## REMARKS

Attached is a marked-up version of the changes being made by the current amendment.

#### Version with markings to show changes made

19B-100 in OLFP (44) 10-12-96 900 Fig 1 I,y lot F = 224 G = 5030mb H = 15mils I = 20 A = 550 mils # - ARRAY CENTER B = 410 mils C = 140 mils D = 112 mils + - PKG, CENTER

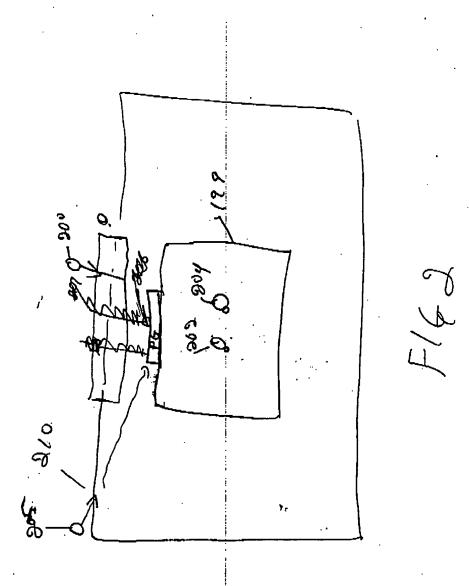
Initially, applicants apologize for the clerical error, in which apparently the original drawings were filed as drawing changes. Attached find new drawing changes including the new reference designations in pink highlighter.

An amendment to the specification referring to all of these designations. In addition, a designation for the array center and the package center have been added, and these are also added to the specification. This should obviate the rejection based on drawings.

Reference numerals for the electrical connections have been added to figure 1 and page 3 which already described these electrical connections.

The final device forms a standard type CMOS die in a totally clear package as shown in Figure 1. The CMOS dies, is, for example, a photosensitive device with electrical connections, for example, an active pixel sensor. The perimeter of the device has these electrical connections, which are connected to the electrical connections 108 on the image sensor chip.

Figure 1 shows the package including different sizes of the different package parts. As shown in figure 1, the package center 102 is inside the array center 101. In addition, the package has a number of different size parameter shown including the size a witch's 550 mills, besides be witch's 410 mills, the size see which is 239 mills, the size of the witch's 112 mills, size the witch's 92 mills, the size F. witch is 224 mills, the size G. witch's 30 mills, the size age witch's 15 mills, and the size by a which is 39 mills.
